*Mountain Chute G2 Excitation System Replacement
Notification of Approval of Connection Proposal
CAA ID Number: 2009-EX433*

**Project: Excitation System Replacement for
Mountain Chute G2**

CAA ID: 2009-EX433

MOUNTAIN CHUTE G2 – EXCITATION SYSTEM REPLACEMENT IESO EXPEDITED SYSTEM IMPACT ASSESSMENT – 2009-EX433

Figure 1: Block Diagram of Excitation System

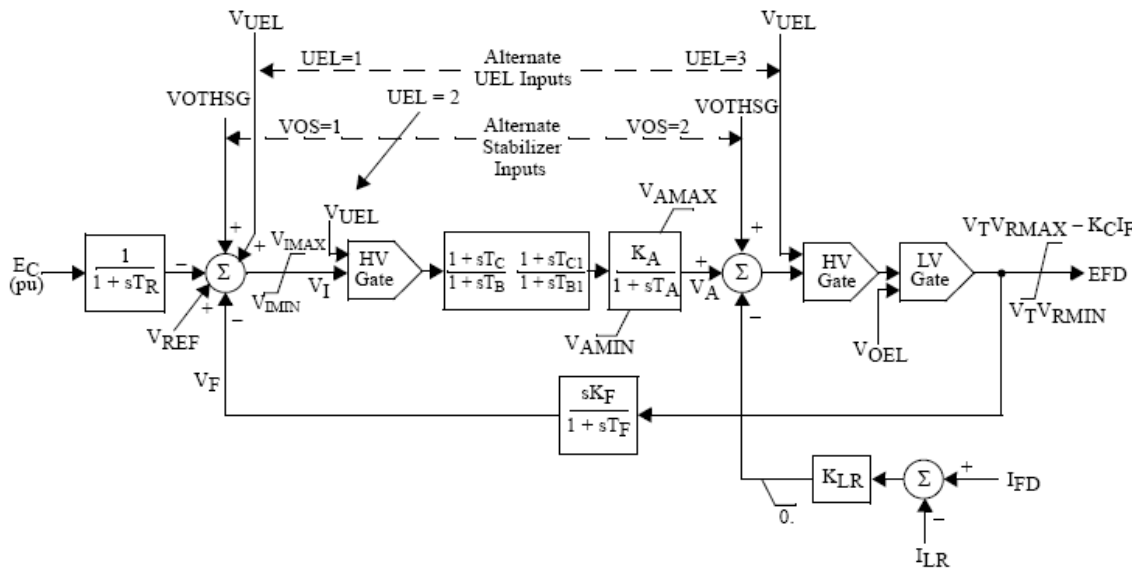
The performance of the proposed exciter has not been verified through testing. After the installation of the proposed exciter, the proponent is required to perform commissioning tests to validate the control model and data. The test results must be supplied to the IESO within three months of the in-service date. If the actual data differs materially from the data that was used in the assessment, then the analysis will need to be repeated.

As soon as the commissioning tests are completed and actual data is available, the connection applicant is required to provide updated block diagram models of the excitation system. Using these data the IESO will perform studies to verify the behaviour of the excitation system and establish the need for any new controls and adjustments, as part of the Market Entry Process.

Figure 2: Block Diagram of PSS

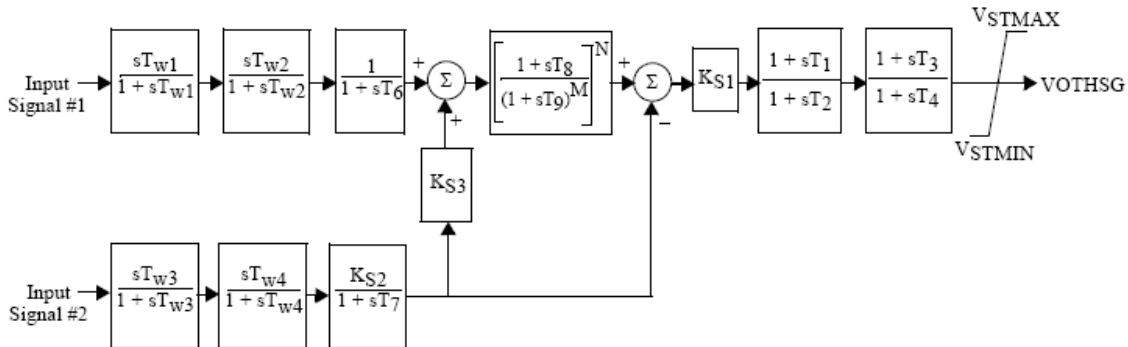
It should be noted that the data in Table 2 are preliminary and the PSS model and data are to be finalized by the connection applicants upon the completion of commissioning test and provided to the IESO in view of completing the Market Entry Process.

Figure 3: Response Ratio Test Results

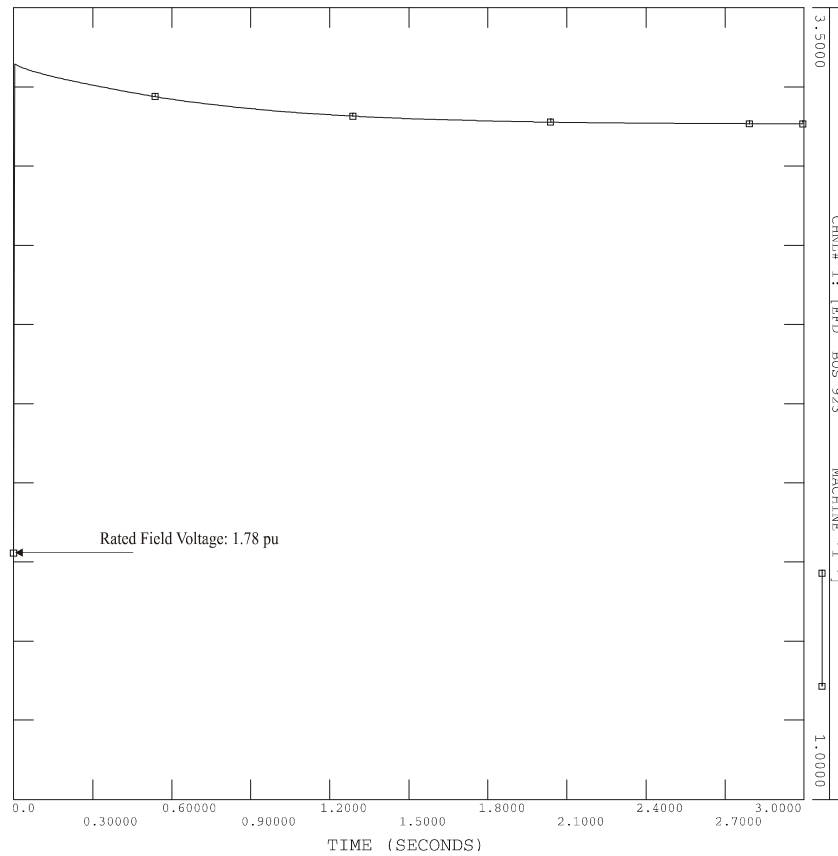
The results of response ratio test shown in Figure 3 indicate that the exciter rated field voltage is 1.78 pu and the response ratio is 3.60.

Therefore, positive ceiling must be at least $2 \times 1.78 = 3.56$ pu for higher requirements or $1.5 \times 1.78 = 2.67$ pu for lower requirements, and negative ceiling must be at least $-1.4 \times 1.78 = -2.49$ pu.

Figure 4: Open Circuit Test Results

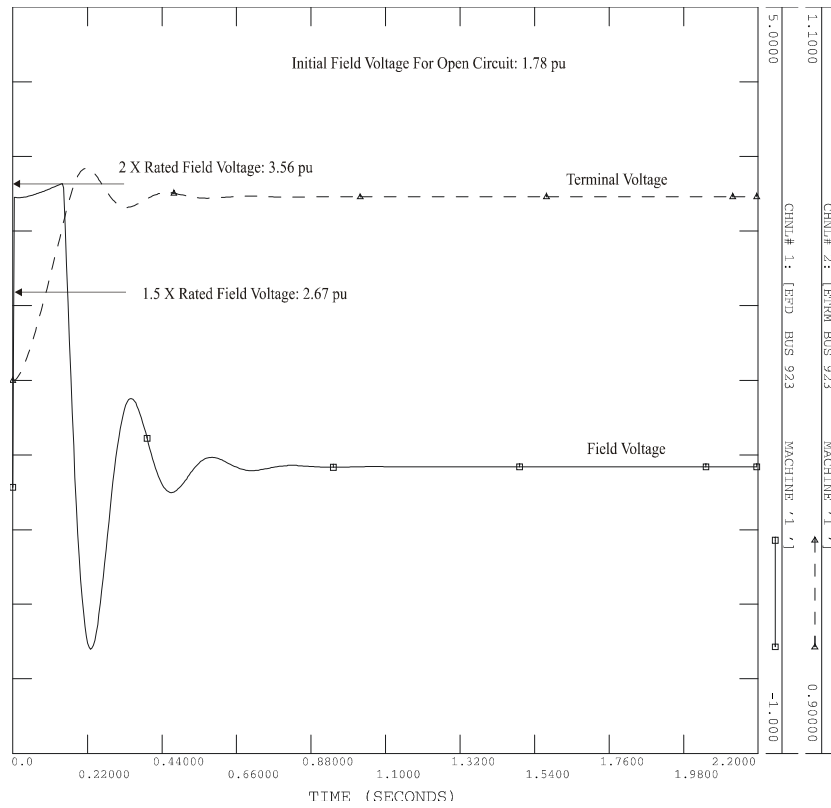
It can be seen that the positive ceiling voltage is 3.15 and meets the above-mentioned lower requirements.

Figure 5: Open Circuit Test Results

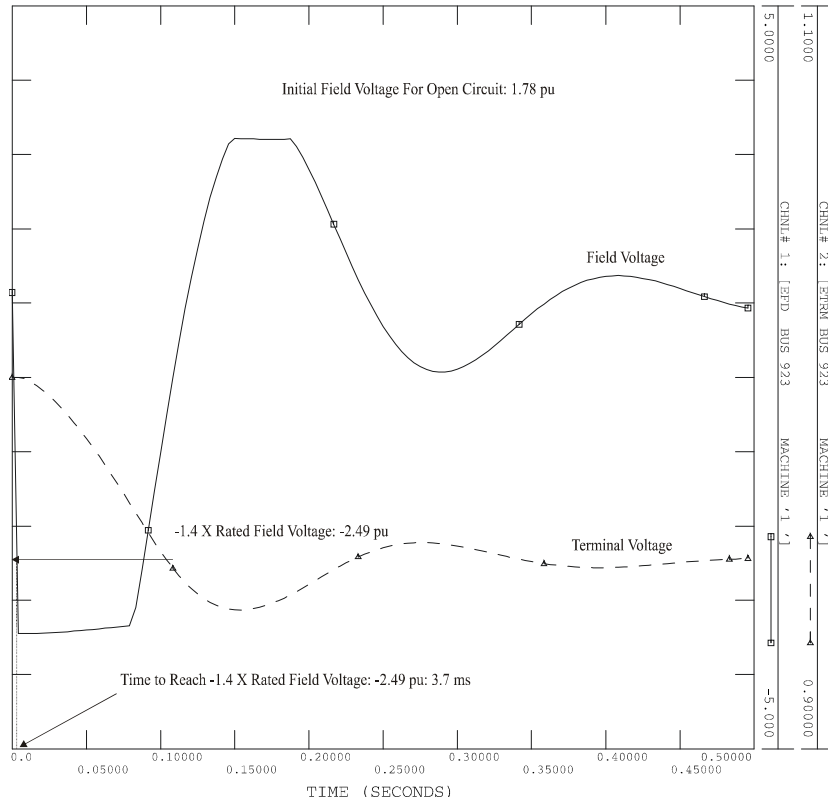
Results in Figure 5 show that the field voltage has a negative ceiling voltage of -3.5 pu which is below the required $-1.4 E_{fd_{rated}}$, -2.49 pu. Examination of the plots indicates that the exciter field voltage reaches $-1.4 E_{fd_{rated}}$ in 3.7 ms for the proposed excitation system.

Therefore, it can be concluded that the negative ceiling voltage for the proposed exciter satisfies Market Rules requirements.

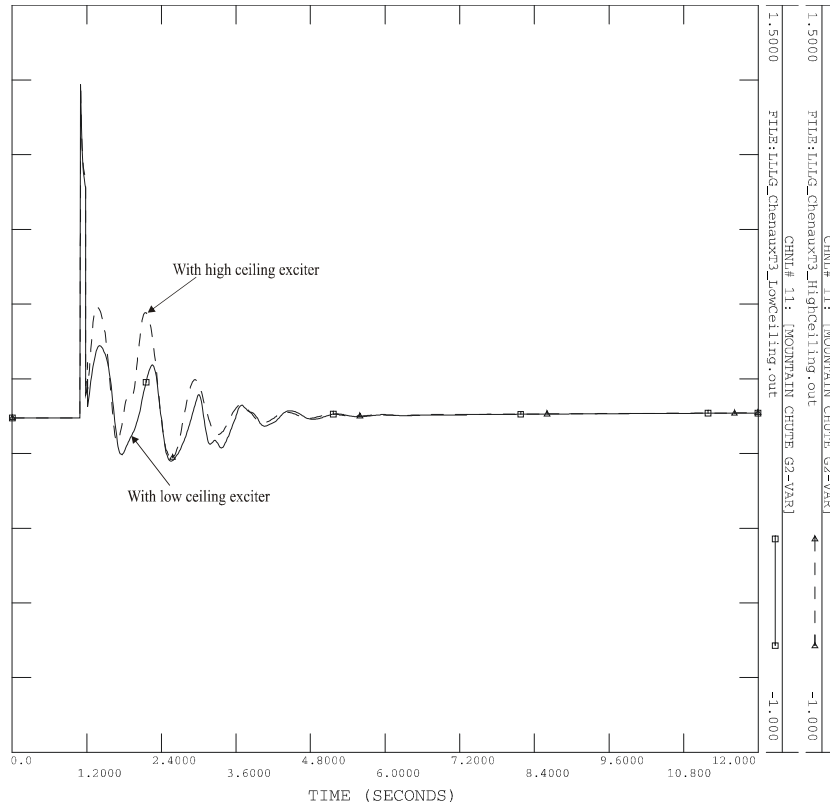
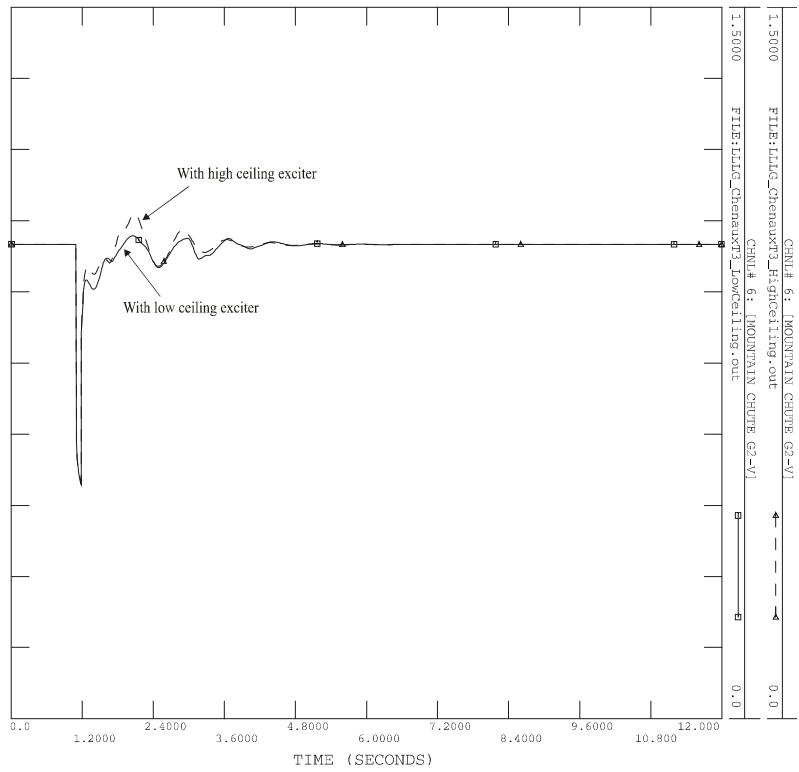
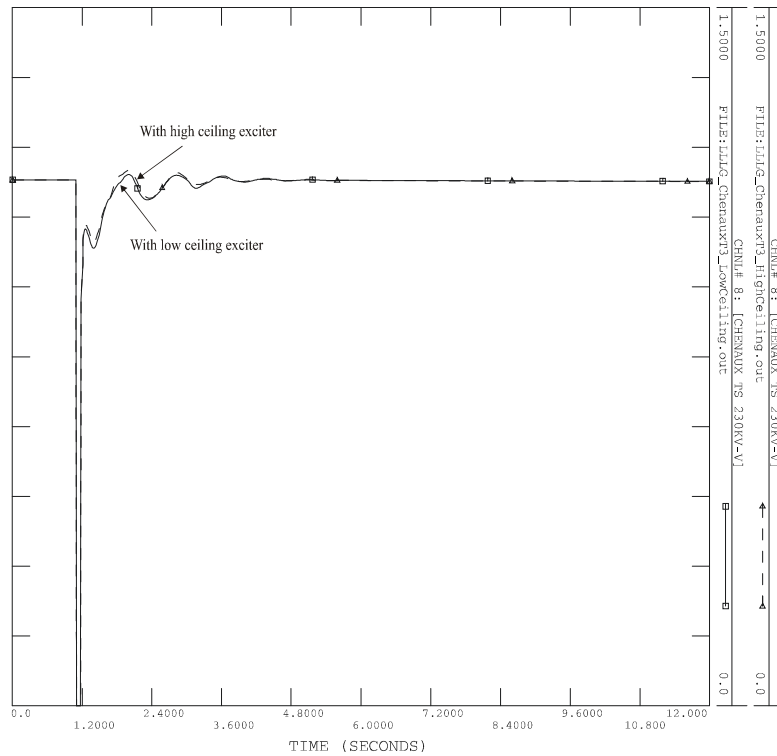
The results show that with a high ceiling exciter G2 at Mountain chute will produce more reactive power during transient and the terminal voltage is a little higher. For the 230 kV voltage at Chenaux TS, the effect of voltage drop resulting from the low ceiling exciter is very slight. Therefore, it can be concluded that the impact of low ceiling exciter is not significant comparing with a high ceiling exciter but it is better to have a high ceiling exciter to contribute more to system stability.

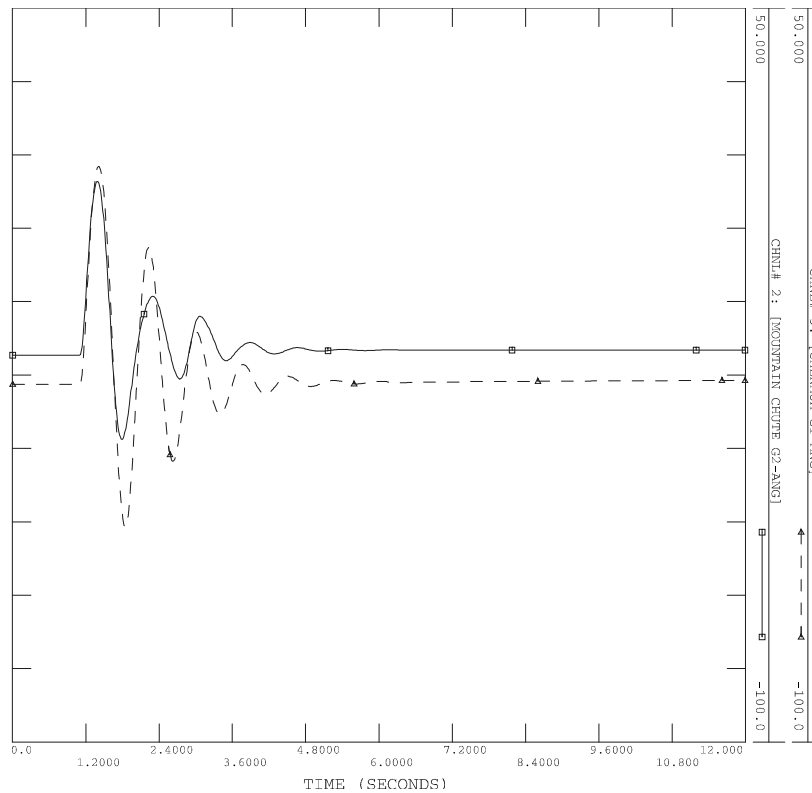
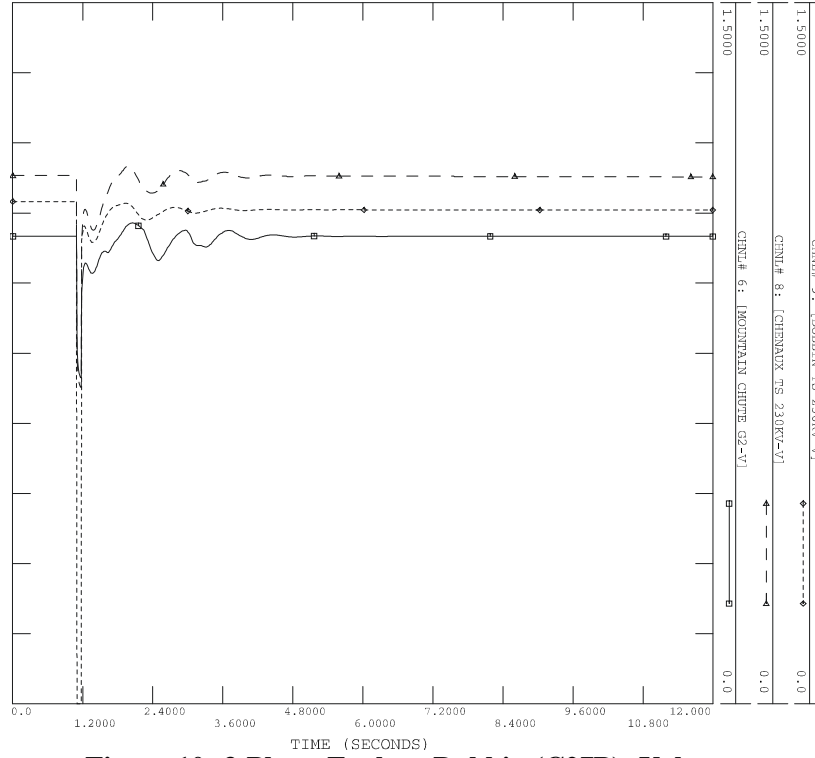
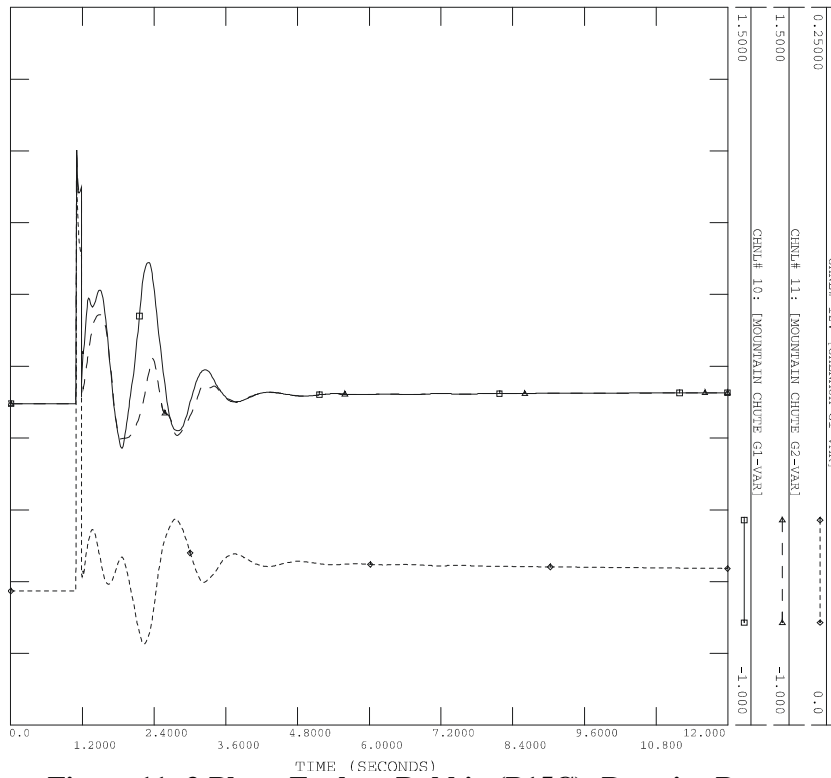
It can be seen that the system displays stable performance and the oscillations are well damped. Therefore, based on the transient stability study results it can be concluded that the proposed replacement of the exciter at Mountain Chute G2 would not adversely impact the reliable operation of the IESO-controlled grid.
